CERTIFICATE OF APPROPRIATENESS PLACARD

219 E NORTH STREET

095-17-MW

to: Tania Tully
re: Exterior Changes and Paint Scheme
Ashley House
219 E North Street
Raleigh, North Carolina 27601

A0201

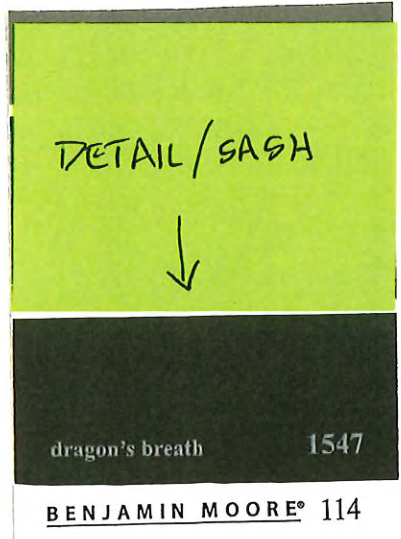
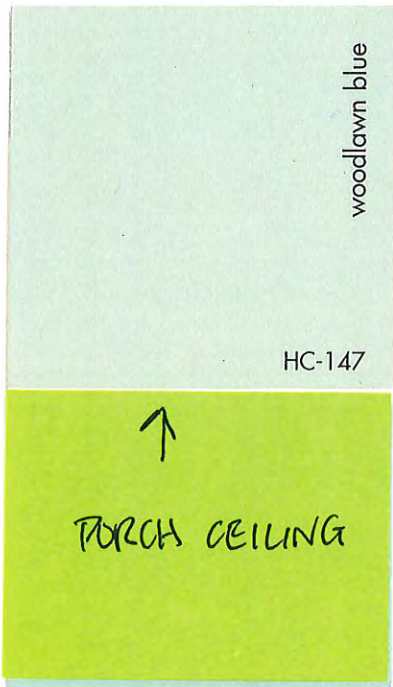
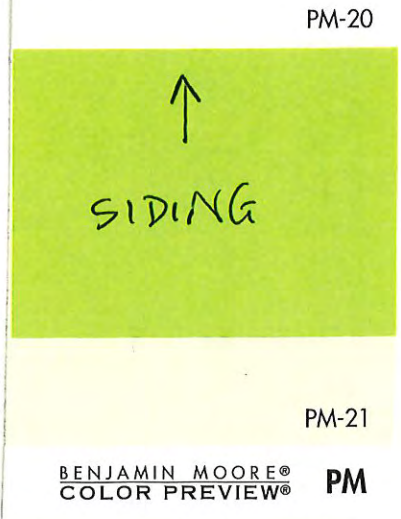
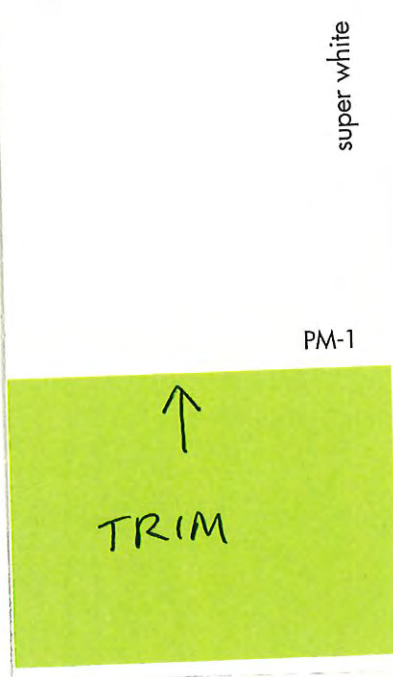
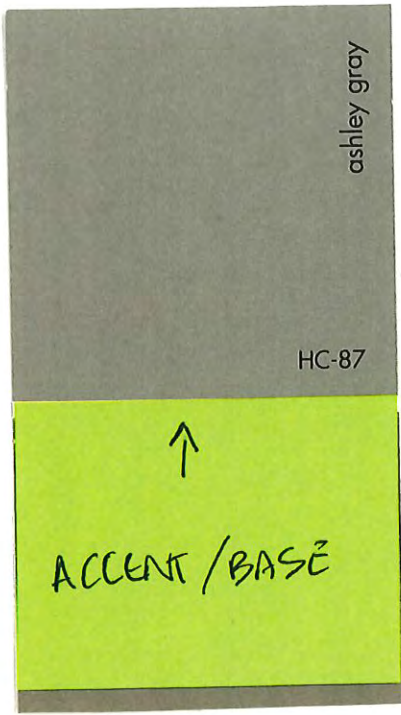
- The drawings show a new pediment/gable entry over the front porch. There is some confusion with the drawings because the existing drawings don't show the current porch roof as shown in the photos. Also, neither the east or west elevations shows this new feature accurately. The application states that there's evidence of a previous feature in this location. **Please provide accurate drawings of both the existing conditions and proposed changes. This change to the porch will be considered a major work unless evidence can be provided to show that the gable/pediment was there historically.**

- Regarding replacing a second-floor window over the front porch: The existing is a small square window and the proposed new window is a double-hung that appears to match others on the front of the house. The application states that there's evidence of a larger window in this location. **Please provide the evidence supporting this, as well as window specifications for the new unit.**

2. Vertical plantings will be installed in order to screen the life from the front, as requested. Attached to this letter are revised architectural sheets A0201 and A0202 with revised exterior elevations.

3. Exterior elevations have been coordinated and revised for consistency, as requested. Attached to this letter are revised architectural sheets A0201 and A0202 with revised exterior elevations. Also attached are photographs of the internal framing at the house to gable connection above the front porch showing evidence of past framing consistent with a front gable and evidence of the current front porch roof as a subsequent alteration and not original to the building

2. Vertical plantings will be installed in order to screen the life from the front. Revised architectural sheet A0201 with a revised front elevation (drawing 01) is attached to this email response.

3. The submitted drawings RHDC 2, the front south elevation, and RHDC 4, the side west elevation, accurately depict the existing conditions. If there are deviations in the existing drawings, then please describe in detail. The proposed side west elevation has been revised to show the proposed front entry gable. Regarding evidence, I have requested photographic evidence that the wall framing around and above the proposed front entry gable including the framing for the front window above the front entry gable has been altered. Furthermore, as evidence, the existing projecting, flat, sloped gable is not historically appropriate or consistent with the Modest Queen Anne style of the building and, thus, a more historically appropriate gable, peaked, as proposed, is more congruent to the building.

A0202

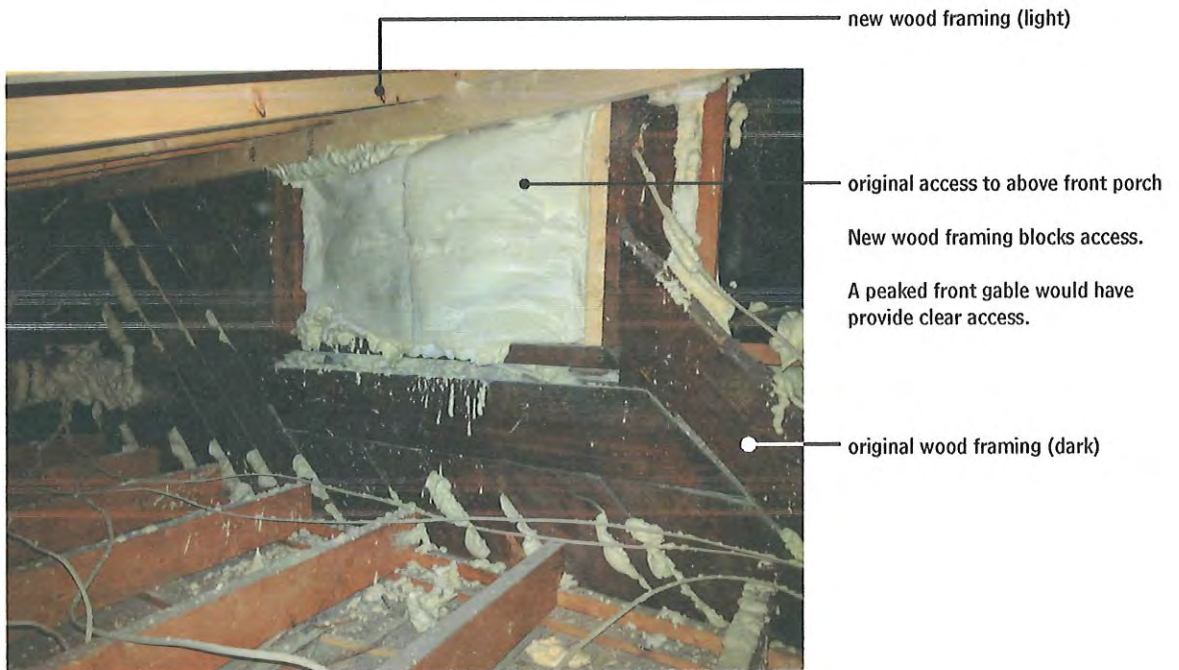
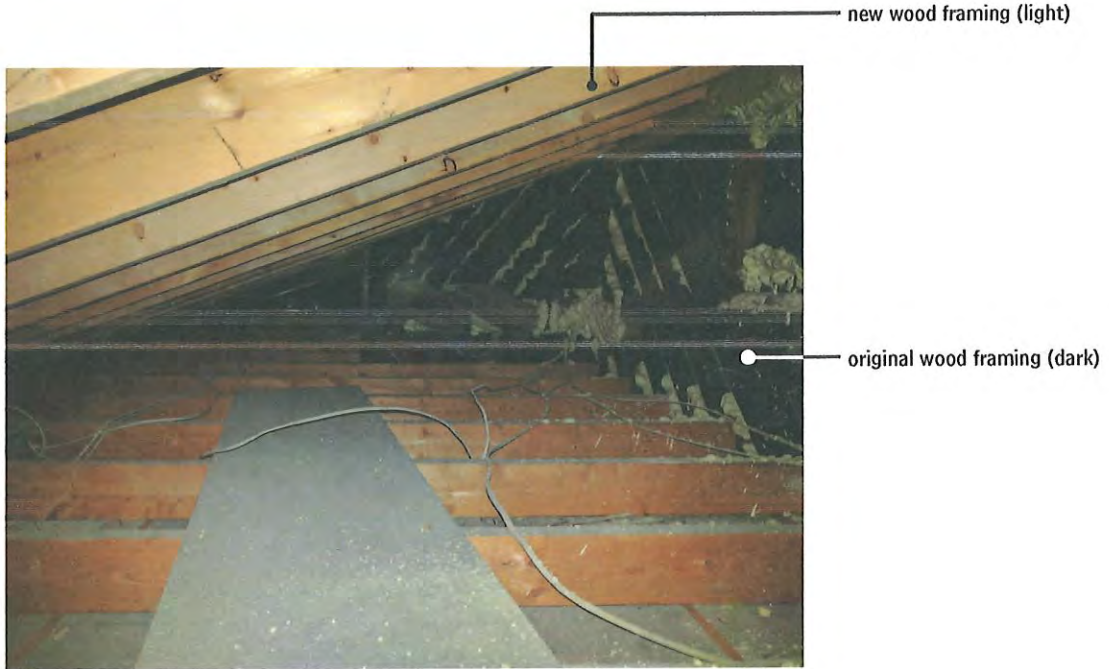
7. Attached is a revised rear (north) elevation on architectural sheet A0202, as requested.
8. Attached are the specifications and brochure of the replacement roofing material, as requested. The roofing is Certaineed Landmark Lifetime Brand in Colonial Slate color.

DOOR PEN
AMENDMENT
RECD 5/24/17
SIDE LIGHT
NOT APPROVED
BY STAFF -
REMOVED BY
APPLICANT 6/1/17

Rear Handrail

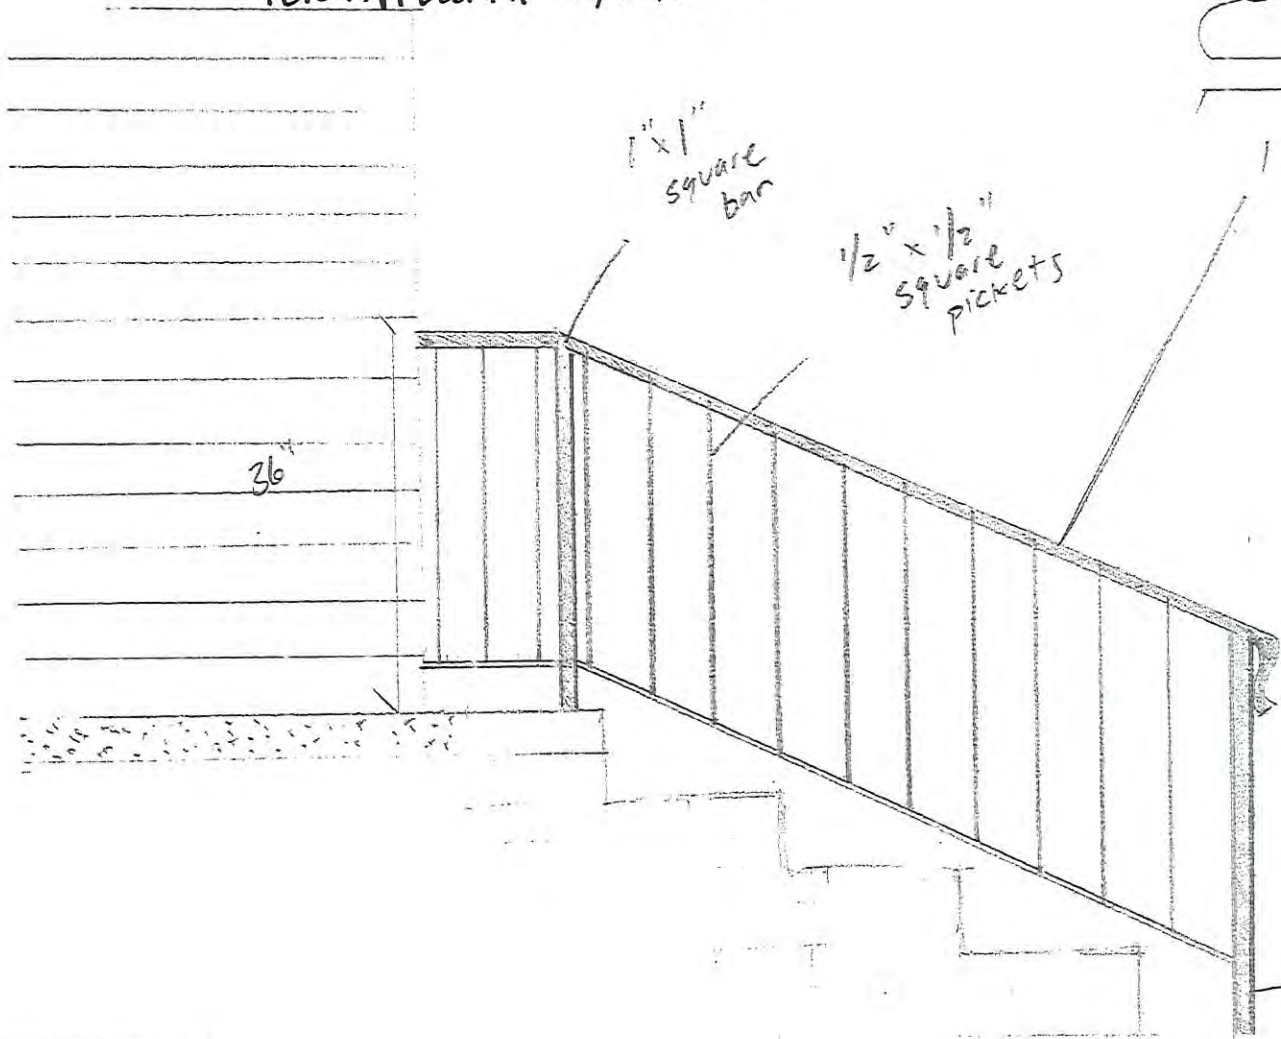
- METAL PAINTED BLACK
- SAME RAILING DESIGN FOR REAR PORCH PER APPLICANT 5/30/17 MR
